Project No: 100211.10

**ADDENDUM NO. 2
TO THE CONTRACT DOCUMENTS AND DRAWINGS**

**For the construction of the
2017 USDA Water System Improvements
Contract 1 – County Road 24 Pump Station Upgrade**

INJECTION DETAIL
 NOT TO SCALE

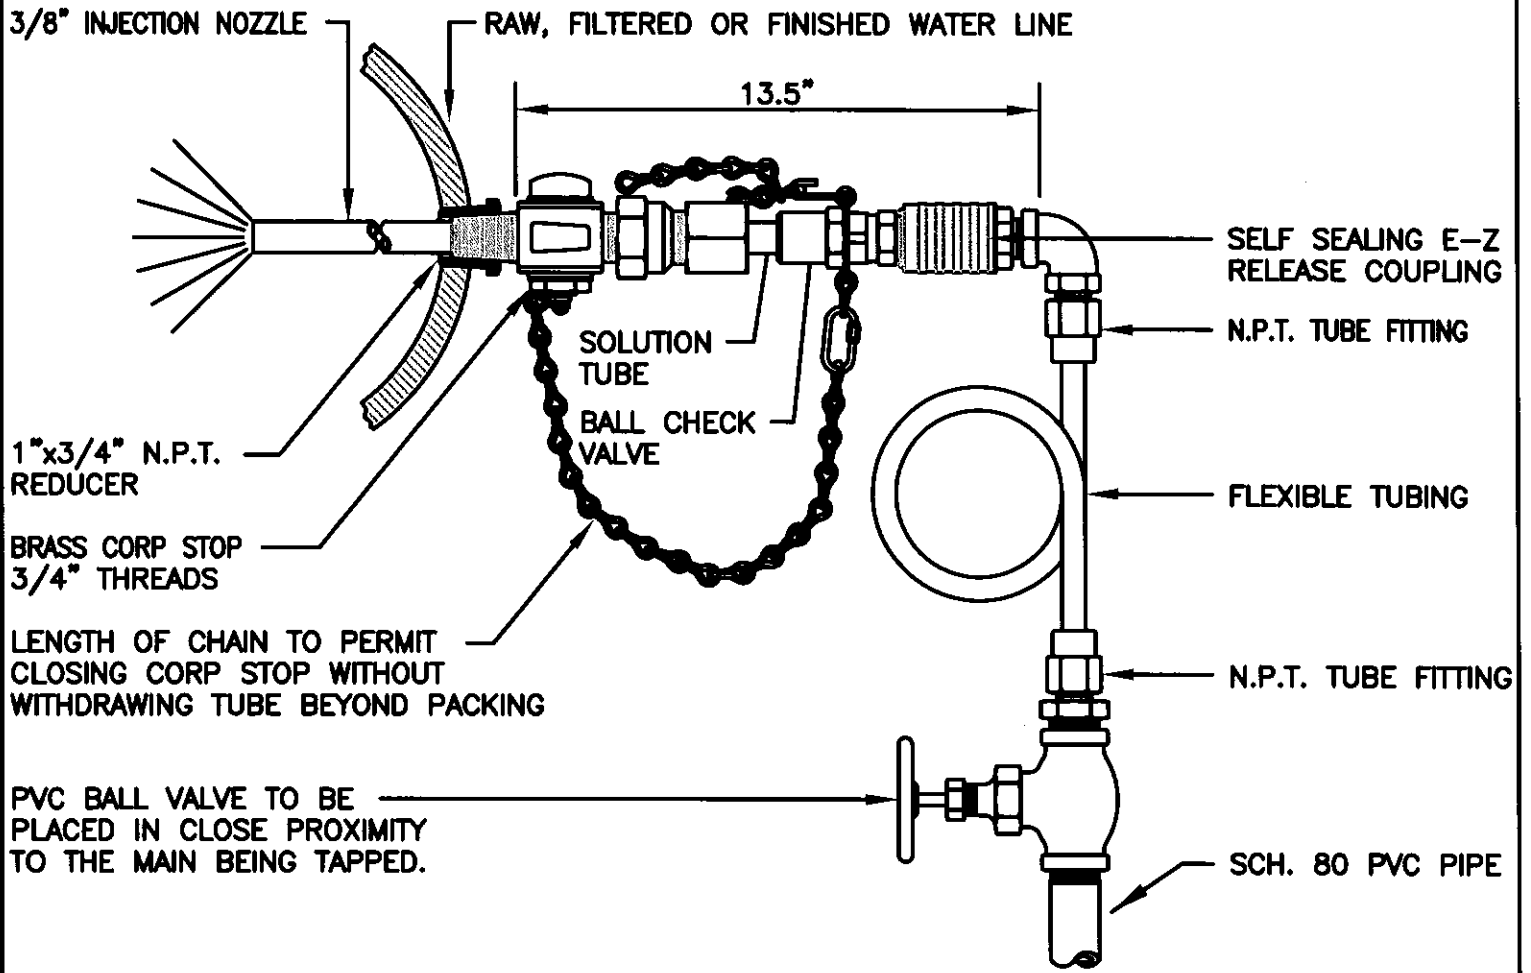
7. Is an injection quil needed at the ¾” tap for the CL line?
YES, SAF T FLO or Equal see attached detail
